August 24, 2011
NRC3-11-0034

Subject: Detroit Edison Company Supplemental Responses to NRC RAI Letter
Nos. 4, 42, and 57

Fermi 3 Combined License Application

Figure 11.4-1R Solid Waste Management System Process Diagram

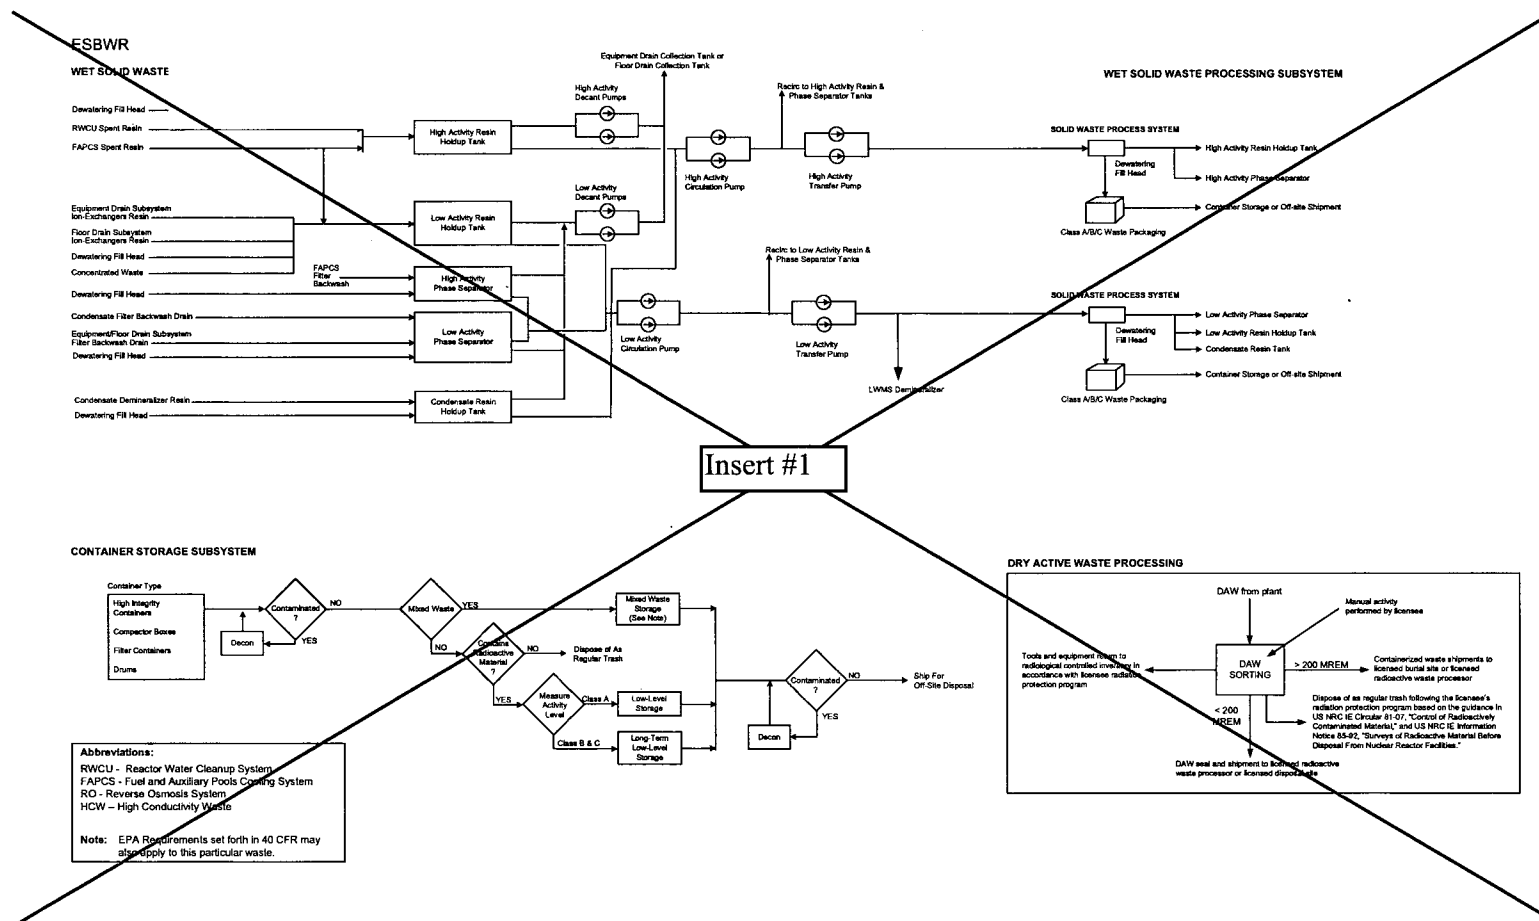
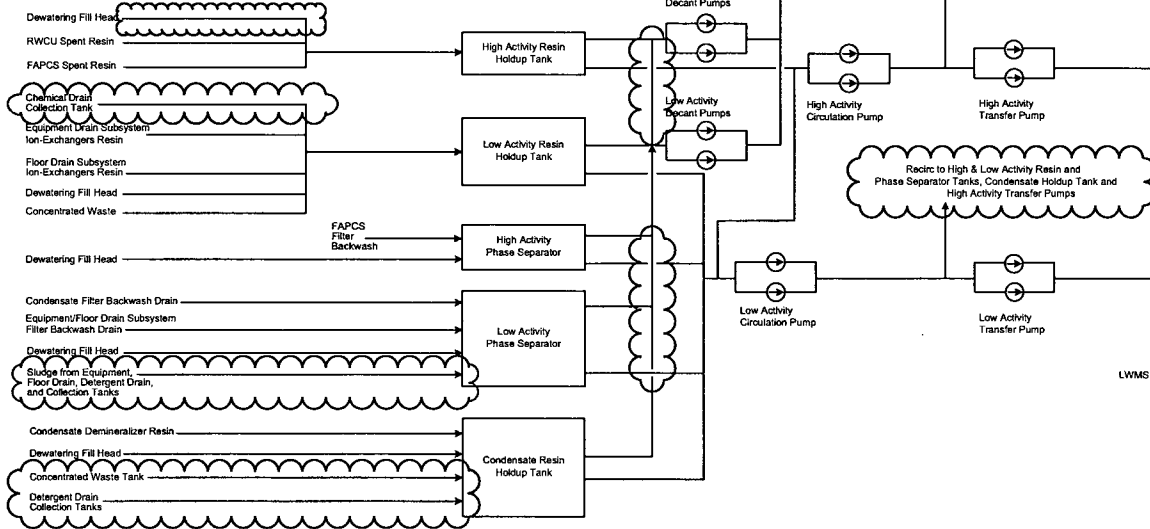
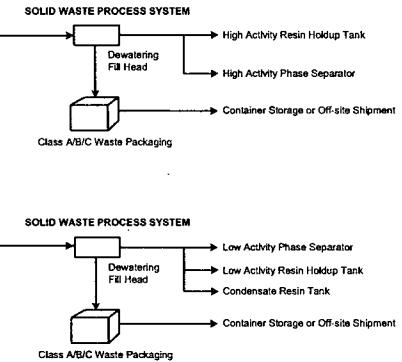
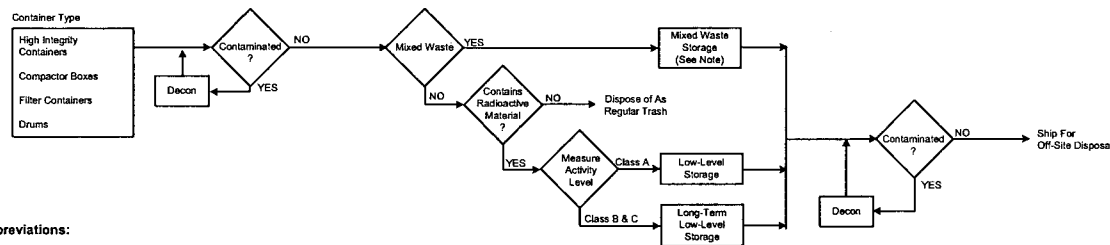
FSAR Section 11.4, "Solid Waste Management System [SWMS]," is incorporated by reference from the ESBWR Design Control Document (DCD), Revision 8, with Departure EF3 DEP 11.4 1. In Revision 3 of Section 11.4, Departure EF3 DEP 11.4-1 indicates changes to system component capacities for the SWMS, and includes Figures 11.4-1R and 11.4-2R, and Tables 11.4-1R and 11.4-2R. Figure 11.4-1R includes the revised system process diagram.

The proposed redesigned solid waste management system included the revised system process diagram in Figure 11.4-1R. However, the process diagram shows pumps in series in two places, with no holding tank or other equipment separating the pumps. This is shown for the:

- 1) Reactor Water Cleanup System (RWCU)/Fuel and Auxiliary Pools Cooling System (FAPCS) – the top process line, showing the high activity circulation and high activity transfer pumps, and*
- 2) Condensate Filter Backwash Drain/Equipment-Floor Drain Subsystem Filter Backwash Drain/Dewatering Fill Head – the lower process line, showing the low activity circulation and low activity transfer pumps. These pumps are shown as tandem units in parallel but the figure does not show if these pumps provide redundancy since they are lacking isolation valves.*

Additionally, the figure appears to be incomplete, in that the detail of the diagram is not sufficient for the NRC staff to fully evaluate whether the system processes are consistent with the regulatory position in Regulatory Guide 1.143 and Branch Technical Position 11-3.

It is not clear from this figure how these pumps are meant to operate, since dual pump units in series may be prone to cavitation. Please provide additional clarifications on the system operation and on the use of these pumps.

Detroit Edison provided a supplemental response to NRC RAI 11.04-4 (eRAI Tracking No. 5633) within Detroit Edison letter NRC3-11-0029, dated August 1, 2011, (ML11215A102) which included a proposed revision of the Fermi 3 solid waste management system process flows on Figure 11.4-1R. As discussed in a conference call with the NRC staff on August 4, 2011, further clarification to support this revision is provided here as a supplement to that response, specifically Figure 11.4-1R is updated to standardize the tank suction point locations and pump feeds such that the decant pump connections are on the top and the circulation pump connections are on the bottom. The following changes have also been made to FSAR Figure 11.4-1R to more clearly depict the system processing capabilities depicted in 11.4-2R:

- The sources feeding into the tanks were revised to identify all feeds depicted in FSAR Figure 11.4-2R.
- The text for the branch flow path shown downstream of the High Activity Circulation Pumps has been updated to reflect the possible recirculation to any tank and the Low Activity Transfer Pumps.

- The text for the branch flow path shown downstream of the Low Activity Circulation Pumps has been updated to reflect the possible recirculation to any tank and the High Activity Transfer Pumps.
- The change in descriptions for the branch flow paths downstream of the High and Low Activity Circulation Pumps eliminates the need for depicting the crosstie line between these pumps and the branch flow paths that was shown in the markup to FSAR Figure 11.4-1R that was part of the supplemental response to NRC RAI 11.04-4 within Detroit Edison letter NRC3-11-0029, dated August 1, 2011, (ML11215A102).

The attached markups supersede the FSAR Figure 11.4-1R markups previously submitted in Detroit Edison letter NRC3-11-0029, dated August 1, 2011, (ML11215A102).
